**MEHL Integrated Waste
Management Facility**

EPA Waste Licence Application
W0129-03. Response to EPA Article
16: Groundwater

Issue 1 | 16 October 2013

**Figure 1.
 All site investigations to date
 (1989 - 2013)**

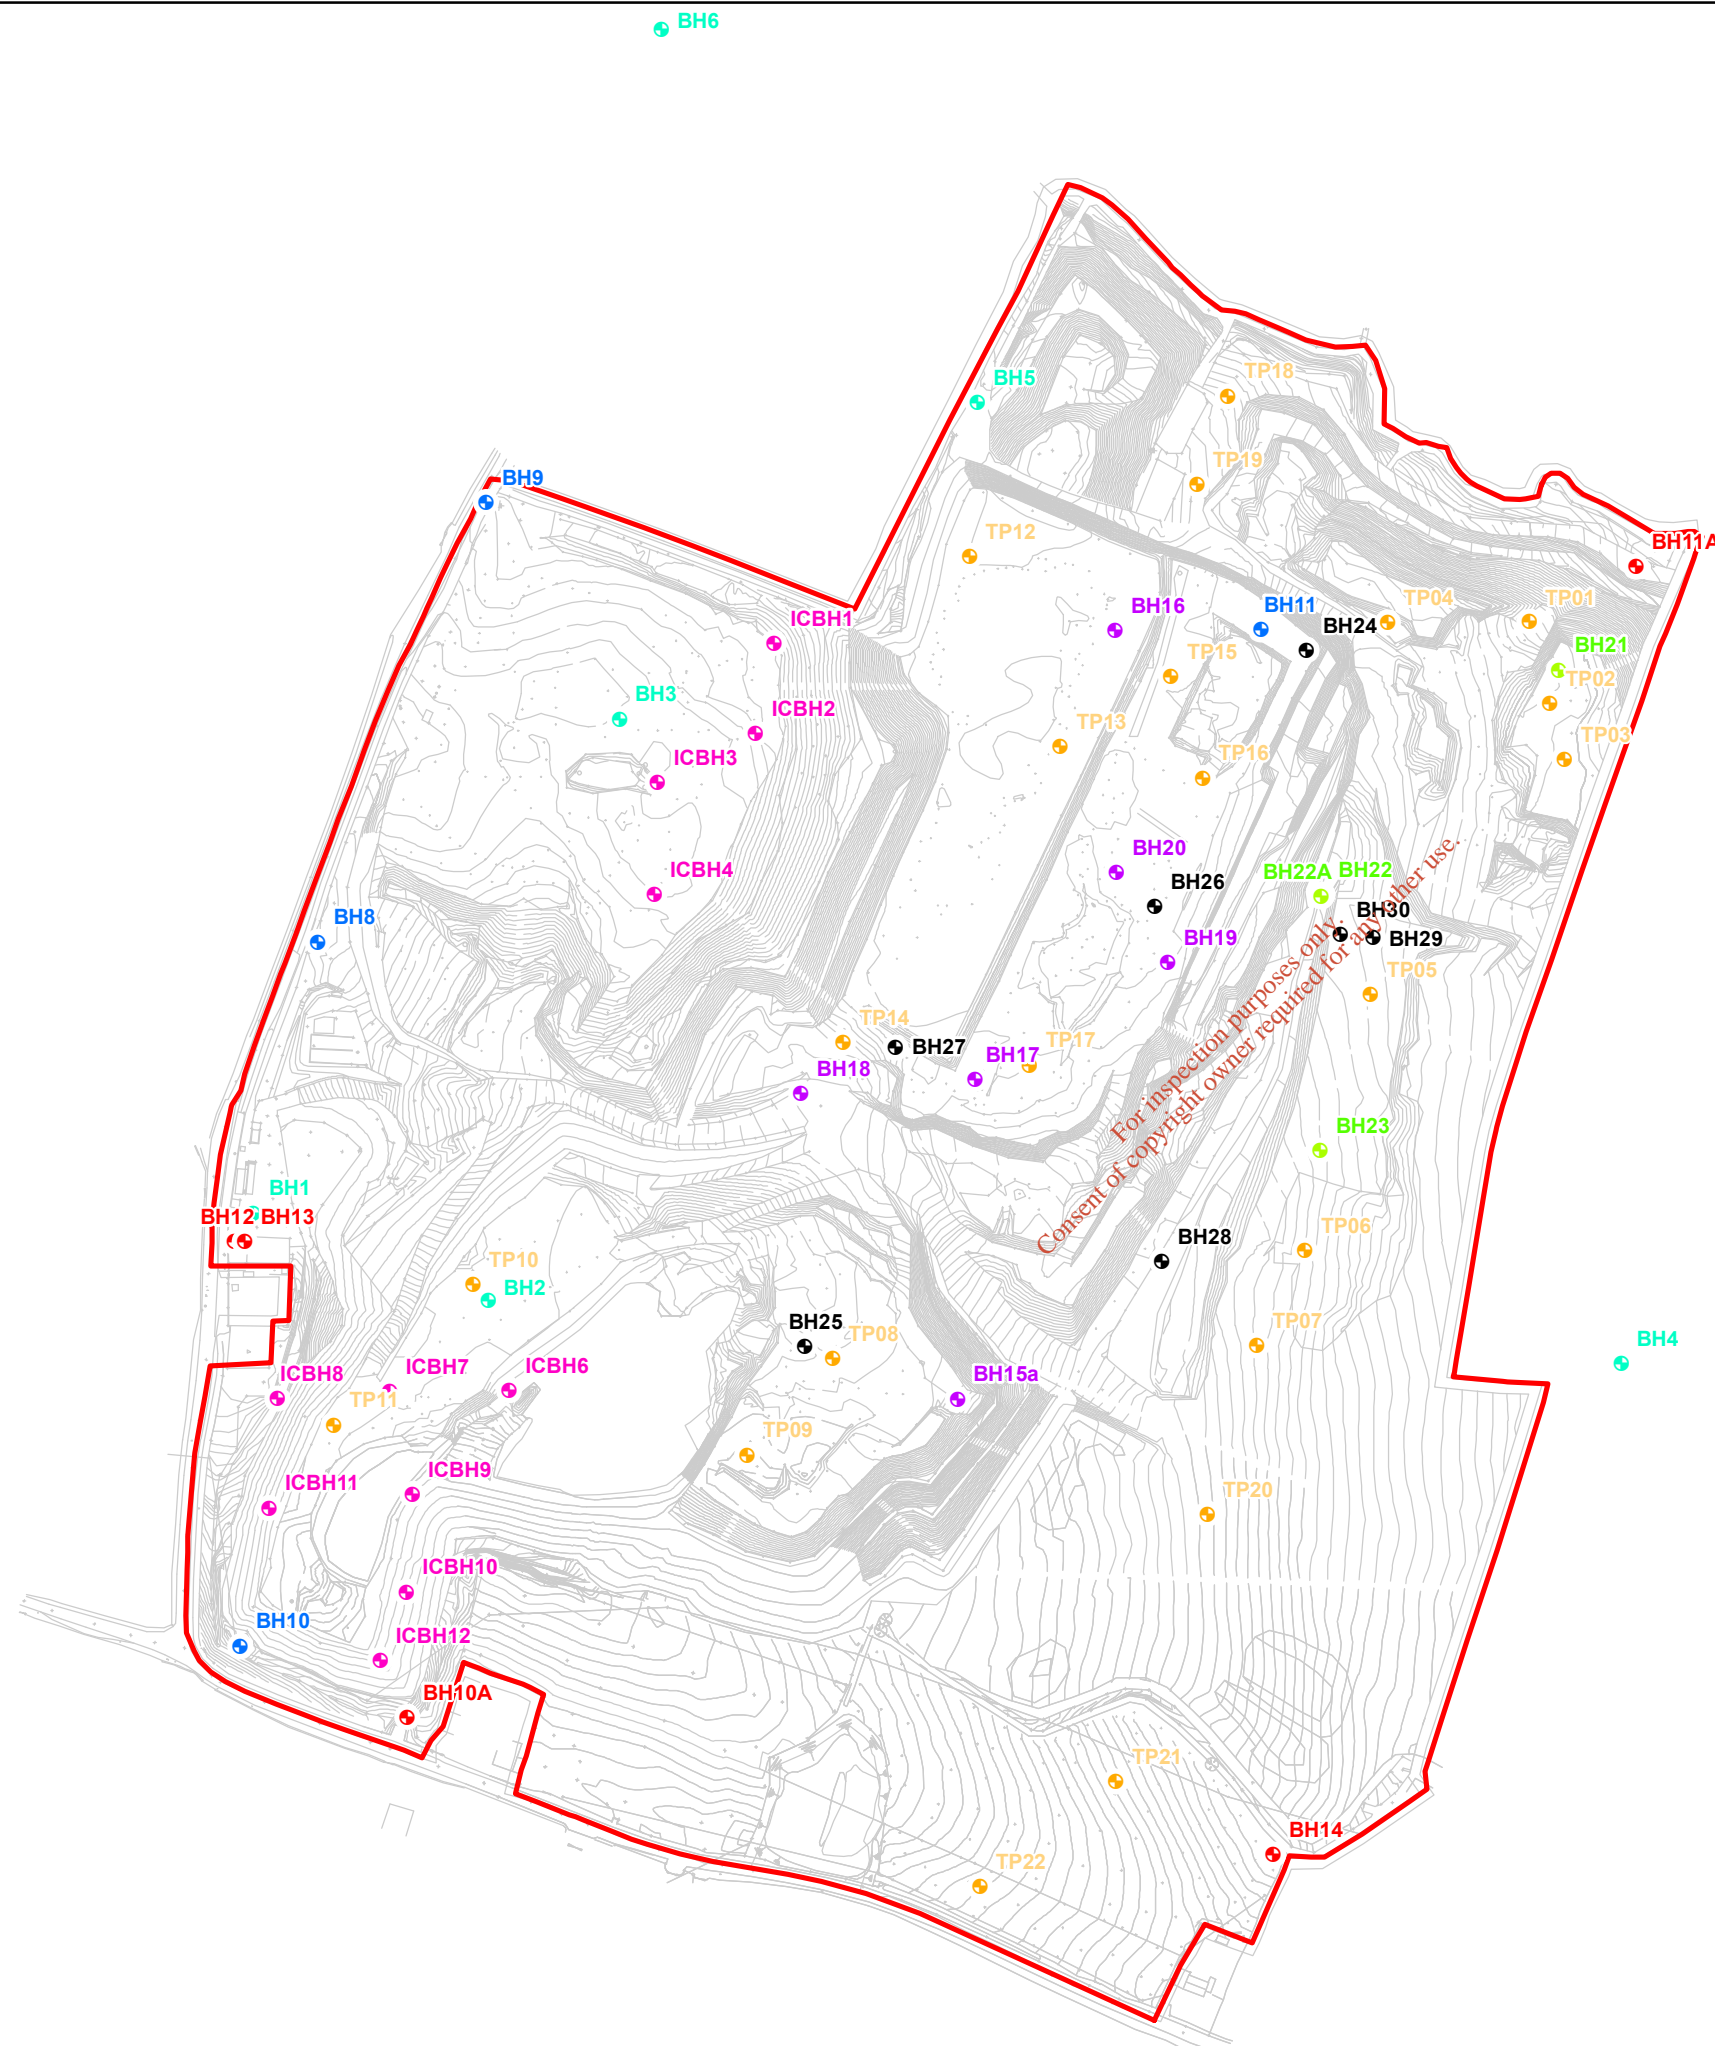
a) A plan showing all site investigation to date (including additional investigations conducted as a result of this notice), and topographic detail extending beyond the licence boundary to the limits of the monitoring points;

d) Figures 14.2, 14.5 and 14.12 show most (not all) of the boreholes and trial pits that have been drilled or excavated on-site: Please provide this information all on one figure. The figure should include topographical detail for the area as a whole (including national grid coordinates), including the area beyond the licence boundary (where off-site monitoring wells and water courses are located).

Topographic detail is presented from within the site and beyond the licence boundary in Figures 1 and 2 respectfully. The latter is reproduced from the Ordnance Survey Discovery Series.

- **Figure 1.** All site investigation locations undertaken to date
- **Figure 2.** All site investigation locations undertaken to date on regional topographic map

Details for BH4, BH10 and BH11 are presented in **Appendix C**. The available logs for all historic boreholes drilled on site are also included in this appendix and their locations have been added to **Figure 1** which presents all explorative holes on site.

Figures 1 and 2 show all exploratory holes for the site on site specific topographic and OS mapping. **Figure 2** also presents the watercourses in the wider area.

Figure 2.
All site investigations to date
on regional topographic map

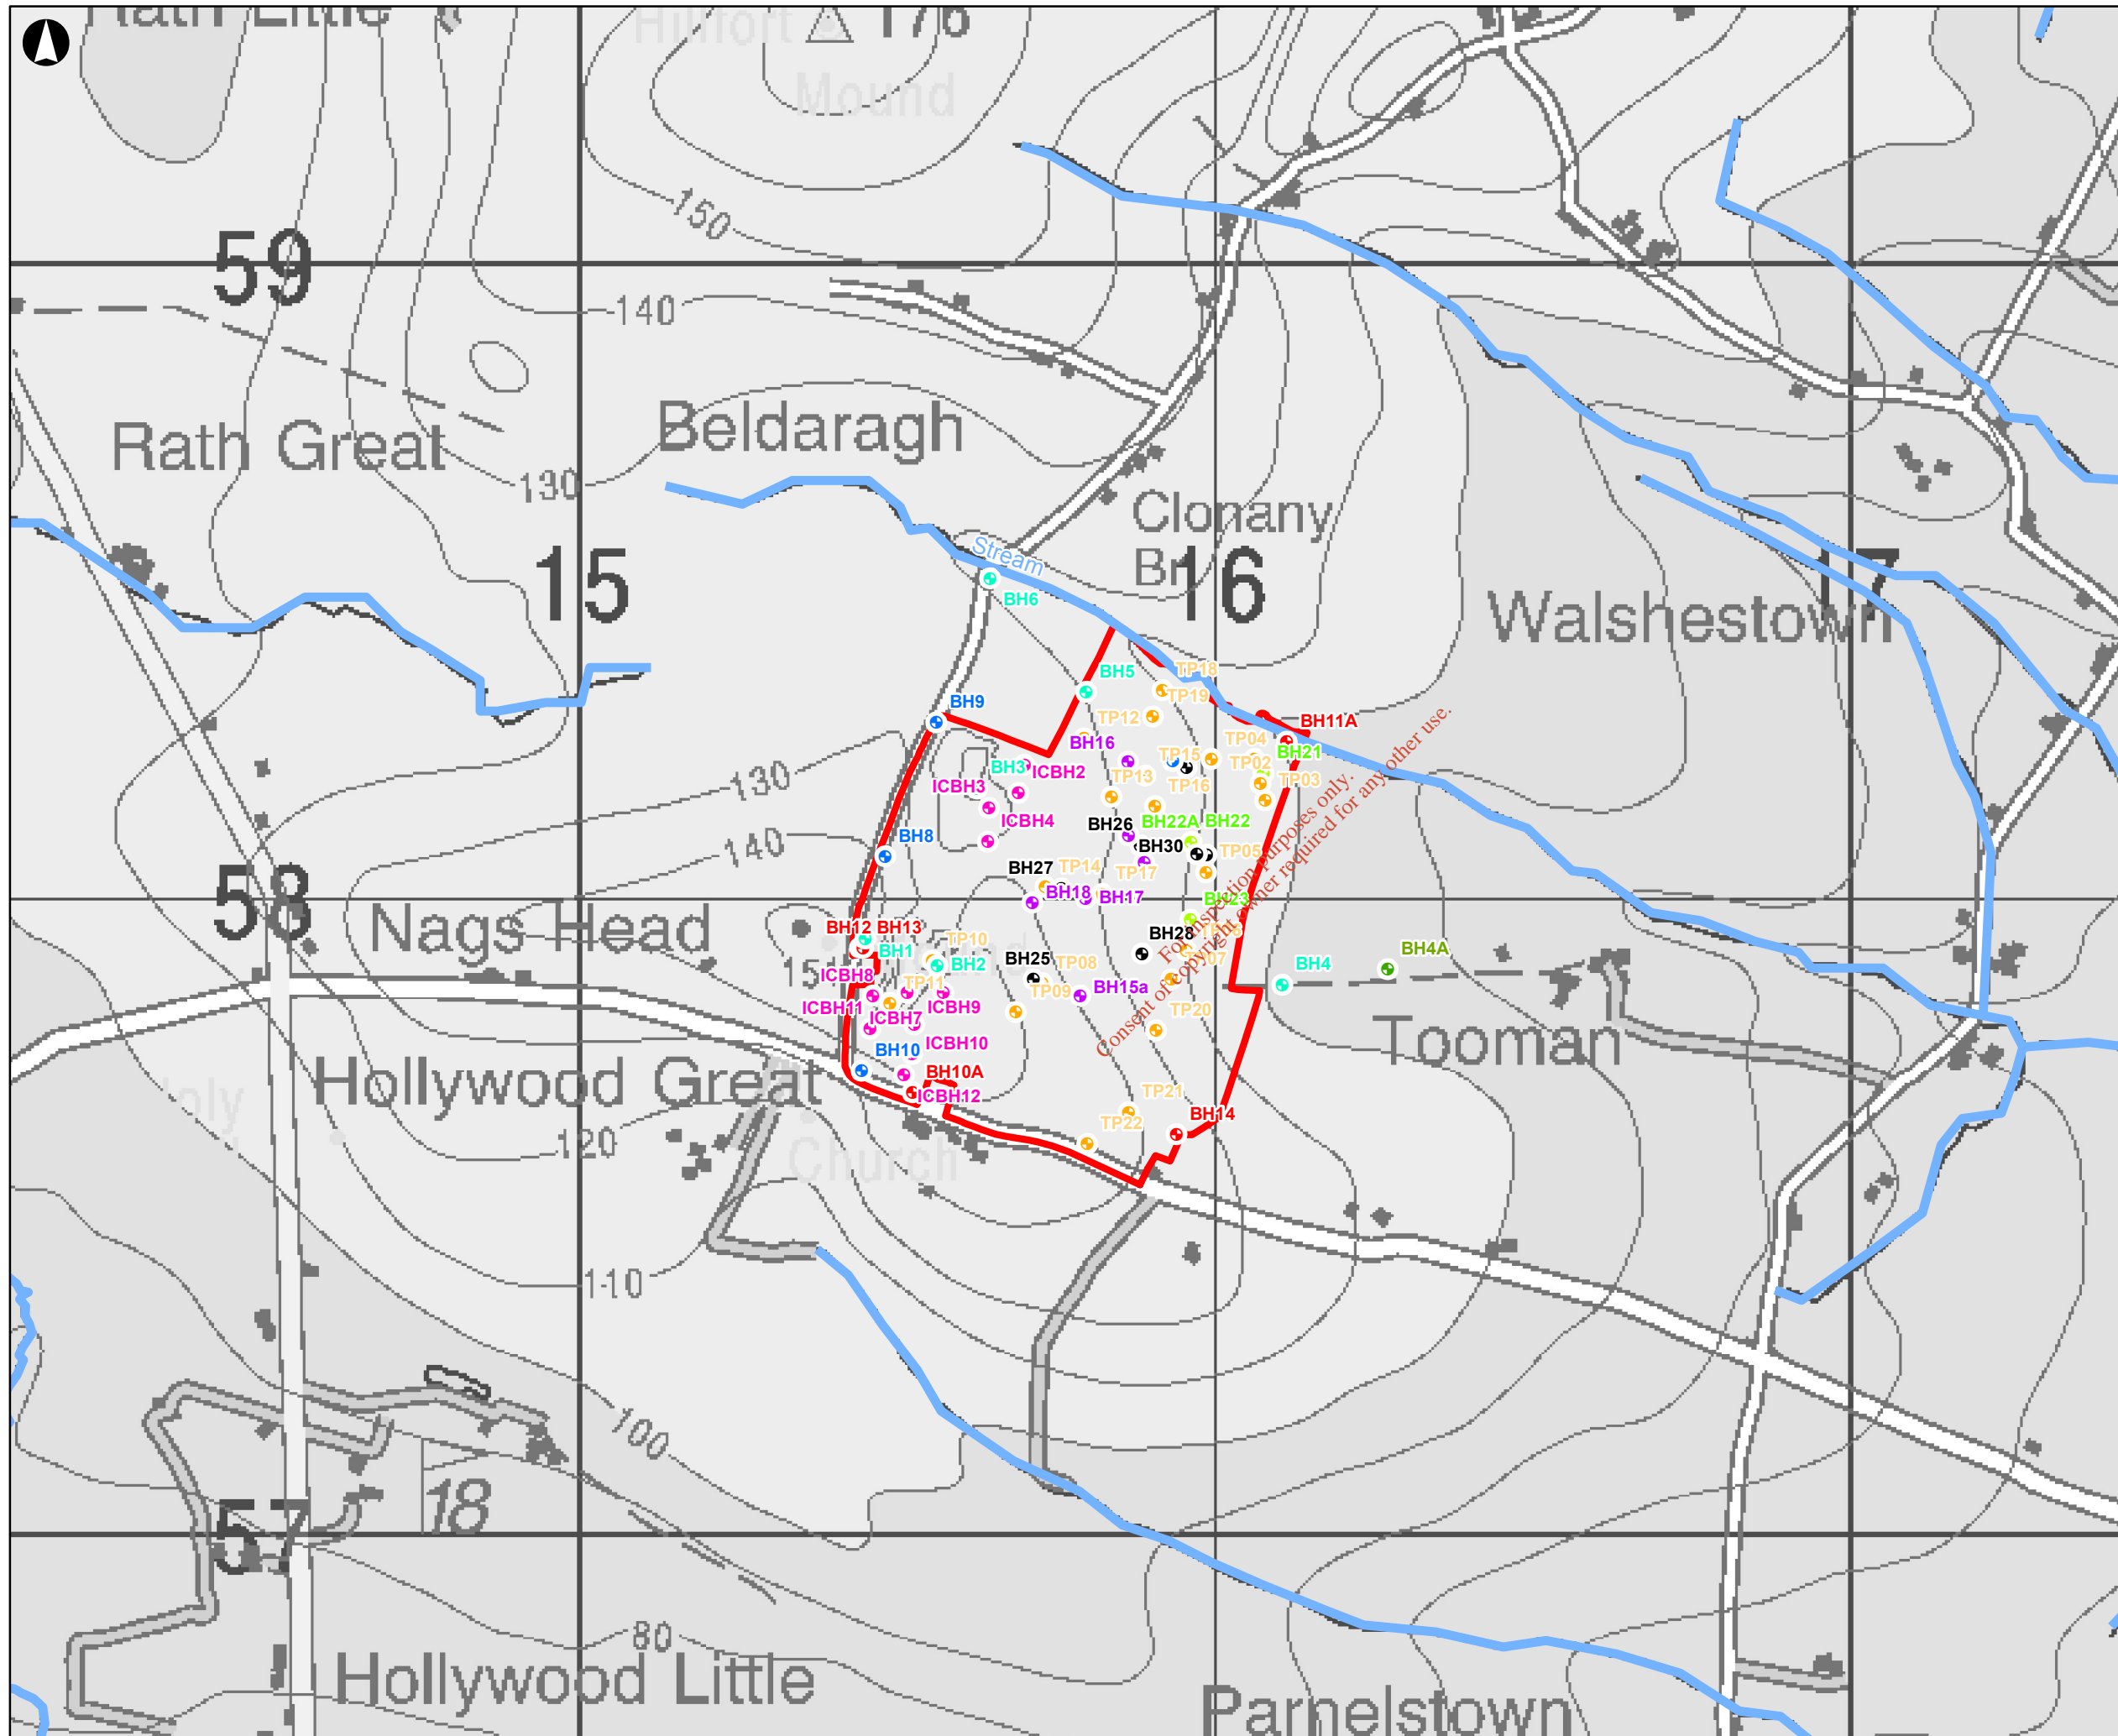
7.4. Illustrate on an appropriate map or drawing the location and course of the stream referred to as being 1.5km to the east of the site and hydraulically connected to the site via groundwater.

Figure 2 presents the surface water features in the region.

The stream referred to is located 1.5 km east of the site and runs north- south, parallel to the site boundary and is presented on **Figure 2**. This stream is hydraulically connected to groundwater in the aquifer and it is likely that groundwater in the Loughshinny Formation discharges at this point.
